## ADDENDUM NO. 2

TO: PLANS AND SPECIFICATIONS FOR STATE OF MISSOURI

Repairs to Interior/Exterior  
Lebanon Readiness Center  
Lebanon, Missouri  
PROJECT NO.: T2507-01

**M-201**

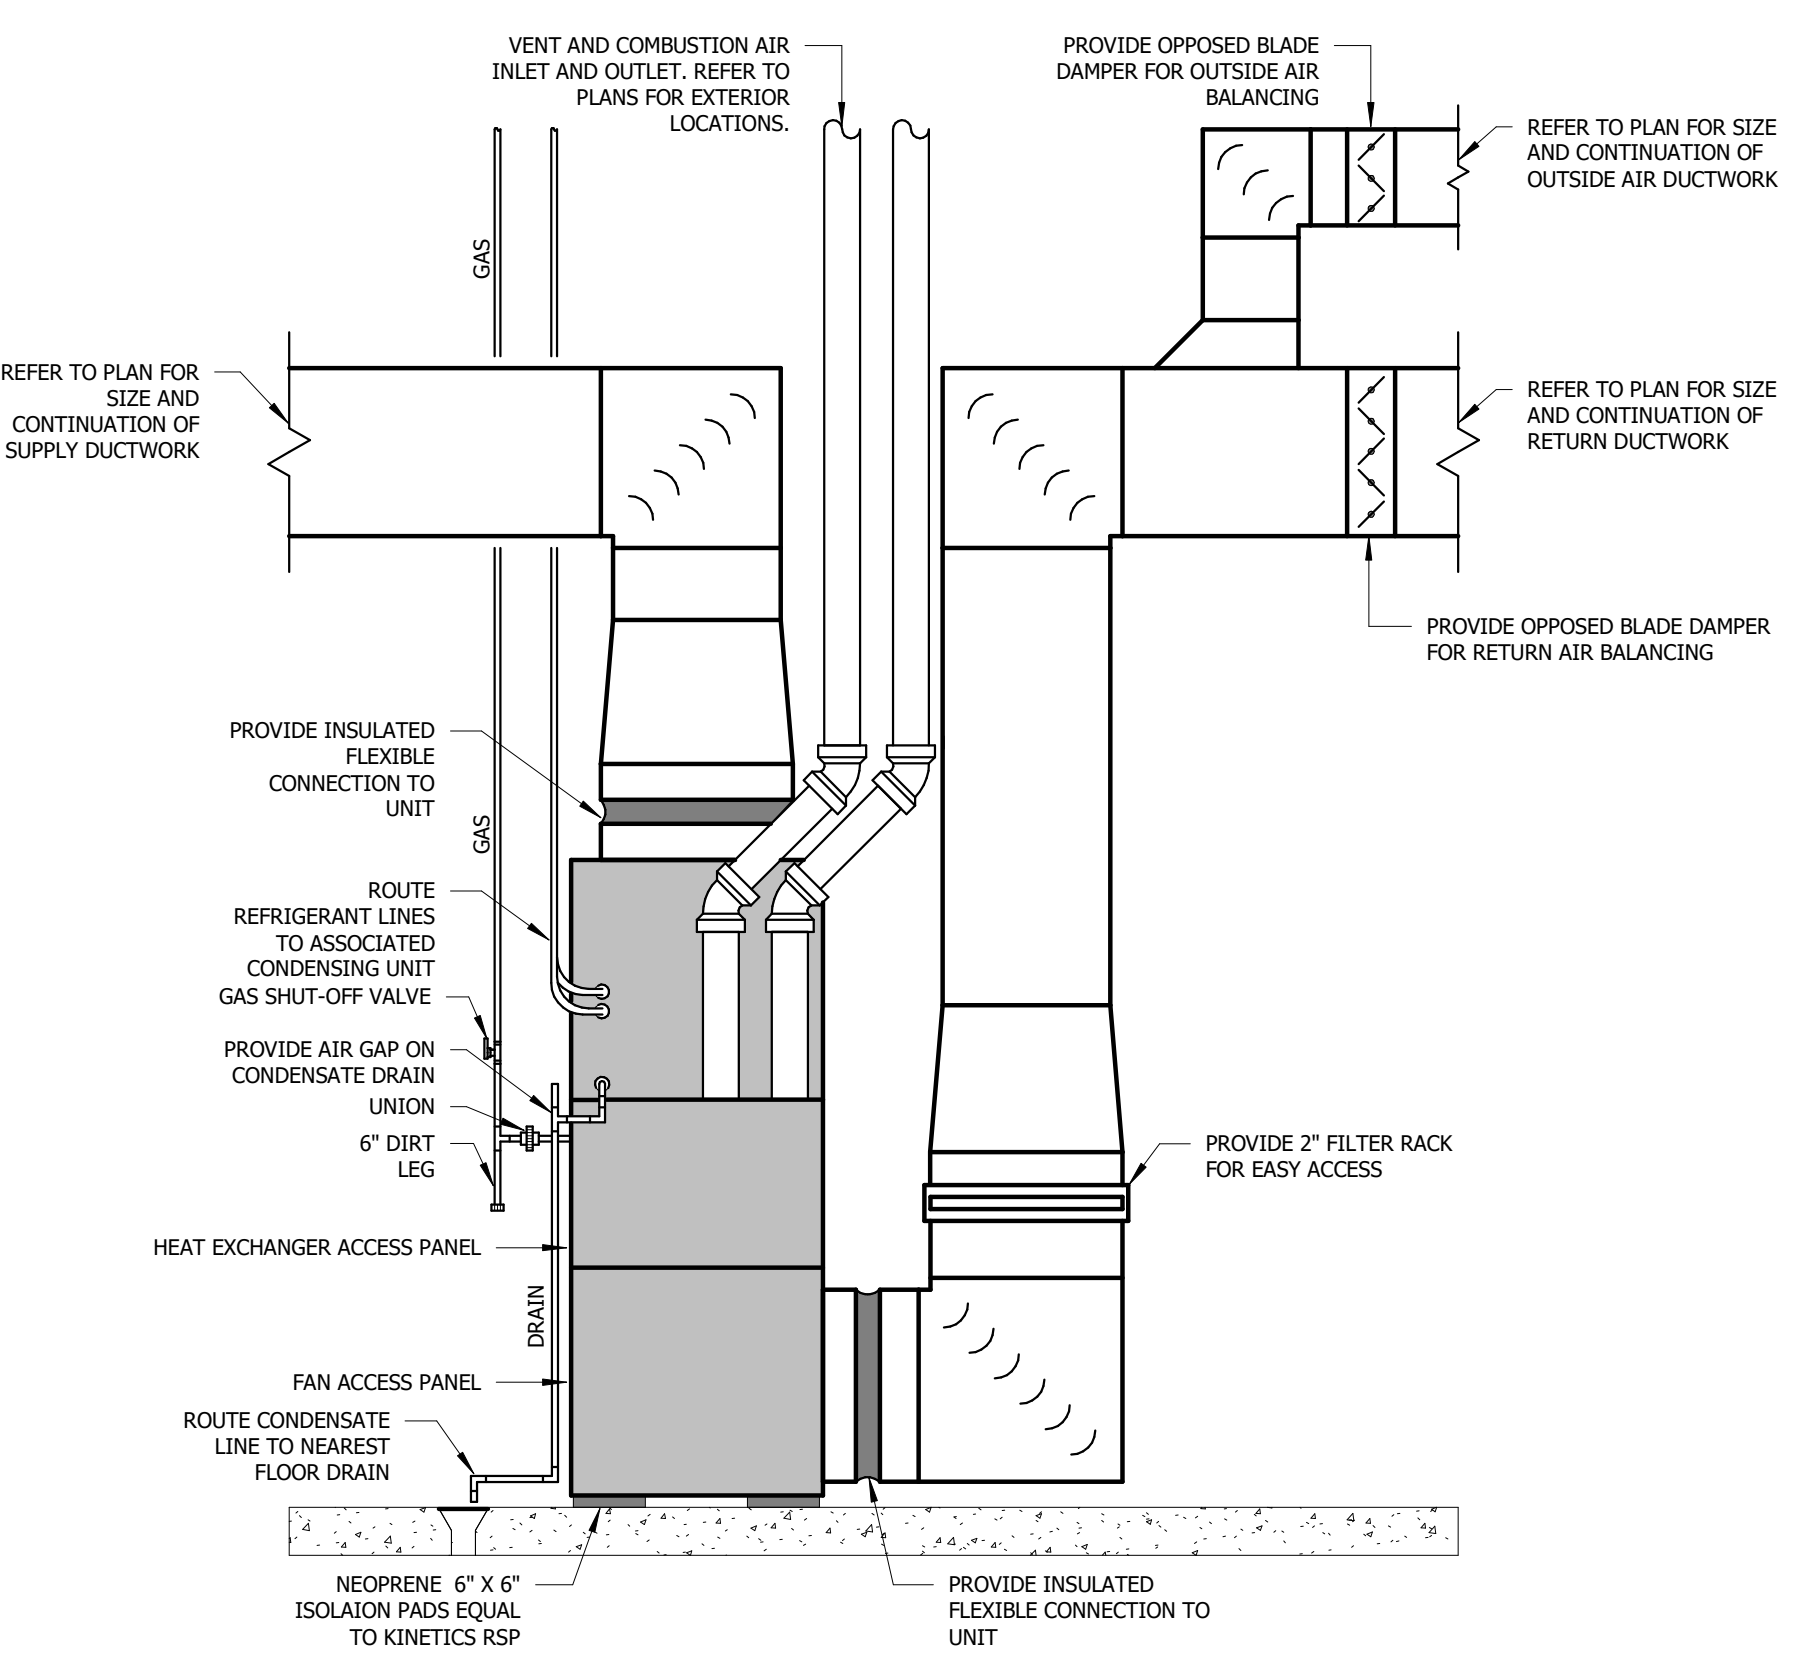
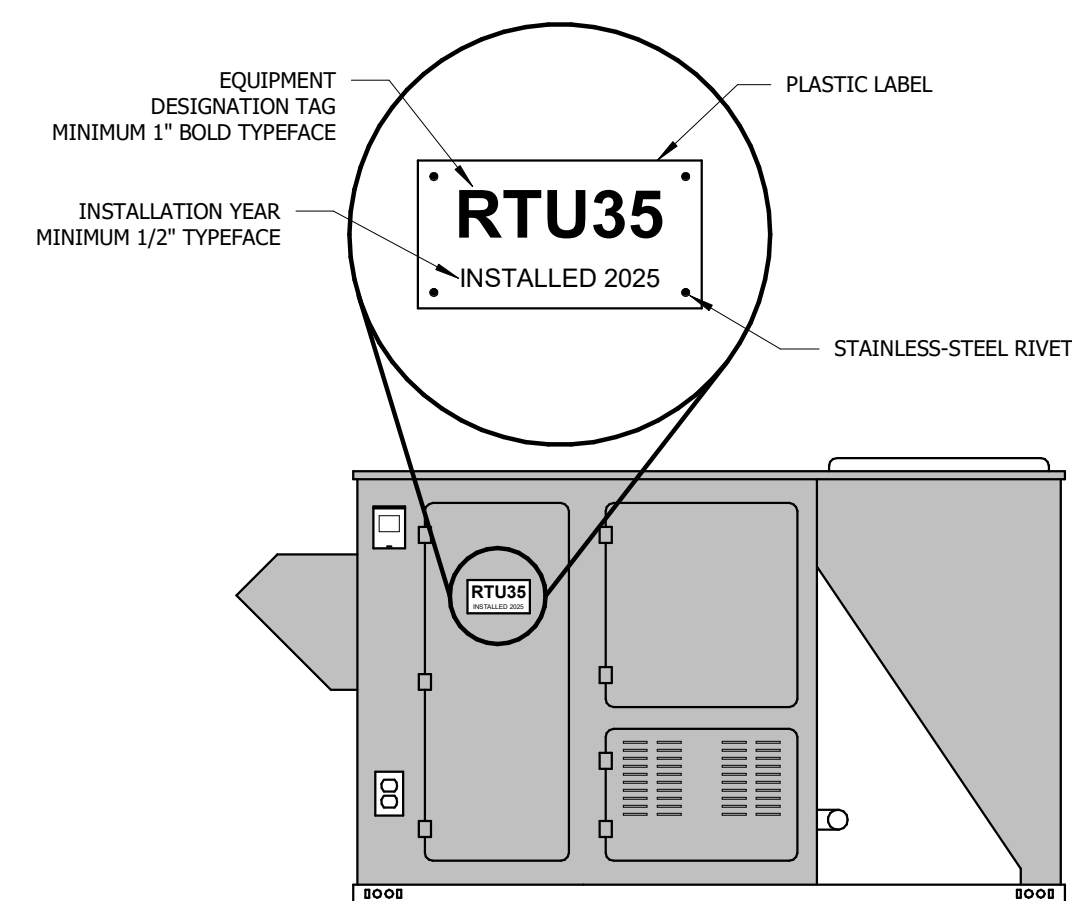
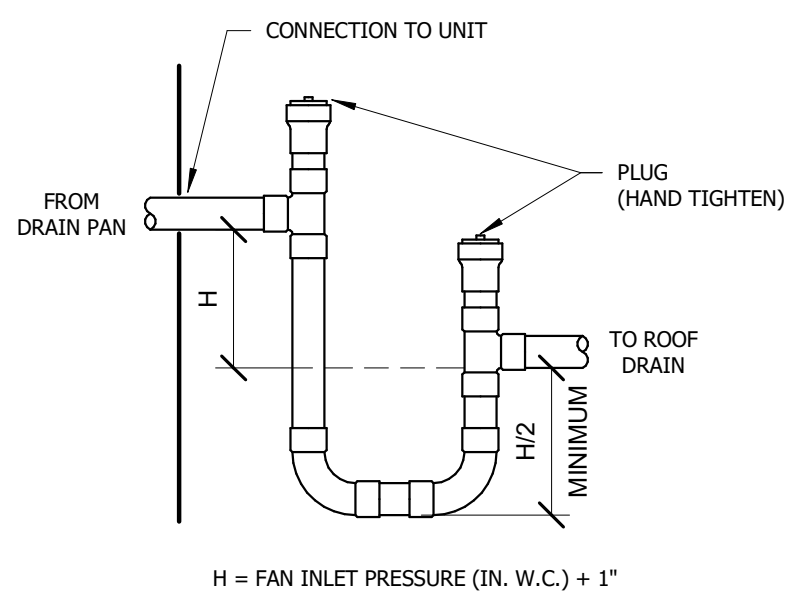
1. Sheet A-002 – DEMOLITION FLOOR PLAN
  - a. Revise to **ADD** removal of existing resilient flooring in Women’s restroom 126.
2. Sheet M-201 – Mechanical Details and Schedules:
  - a. Refer to “Heat Pump Condensing Unit Schedule”:
    - i. Revise schedule per attached sheet AD02-M-201.
  - b. Refer to “furnace Schedule”: Revise note per attached sheet AD02-M-201.

TYPE MARK	MANUFACTURER	TONNAGE	CONDENSER MODEL NUMBER	COOLING				HEATING			MCA	MOCOP	VOLTAGE	NOTES	EQUIVALENTS
				ENTERING AIR DB	ENTERING AIR WB	SENSIBLE (MBH)	TOTAL (MBH)	ENTERING AIR DB	TOTAL (MBH)	LEAVING AIR DB					
CU01	RHEEM	4	RP15AY48AJ2NA	72	60	35.5	43.2	68	33.4	90	28	45	208/1	1,2,3,4	SEE SPECS
CU02	RHEEM	2	RP15AY24AJ2NA	72	60	18.0	22.2	68	15.4	90	21	35	208/1	1,2,3,4	SEE SPECS
CU03	RHEEM	4	RP15AY48AJ2NA	72	60	35.1	42.5	68	33.6	90	28	45	208/1	1,2,3,4	SEE SPECS
CU04	RHEEM	2	RP15AY24AJ2NA	72	60	17.7	20.8	68	15.4	90	21	35	208/1	1,2,3,4	SEE SPECS
CU05	RHEEM	3	RP15AY36AJ2NA	72	60	22.3	25.8	68	33.9	90	22	35	208/1	1,2,3,4	SEE SPECS

TYPE MARK	MANUFACTURER	MODEL NUMBER	SUPPLY AIR (CFM)	OUTSIDE AIR (CFM)	EXTERNAL STATIC (WC)	ENTERING AIR DB	HEATING INPUT (MBH)	HEATING OUTPUT (MBH)	LEAVING AIR DB	MCA	MOCOP	VOLTAGE	NOTES	EQUIVALENTS
F01	RHEEM	R96VA0852521MSB	1600	-	0.5"	68	84	82	95	8.8	20	120/1	1,2,3,4,5	SEE SPECS
F02	RHEEM	R96VA0402317MSA	800	-	0.5"	68	42	41	95	5.9	15	120/1	1,2,3,4,5	SEE SPECS
F03	RHEEM	R96VA1152524M5A	1600	-	0.5"	68	112	109	95	8.6	20	120/1	1,2,3,4,5	SEE SPECS
F04	RHEEM	R97VA07019137USA	800	-	0.5"	68	70	68	95	6.1	15	120/1	1,2,3,4	SEE SPECS
F05	RHEEM	R96VA0702317MSA	1000	-	0.5"	68	70	68	95	6.1	15	120/1	1,2,3,4	SEE SPECS
F06	RHEEM	R96VA1152524M5A	1600	1000	0.5"	0	112	109	90	8.6	20	120/1	1,2,3,4	SEE SPECS
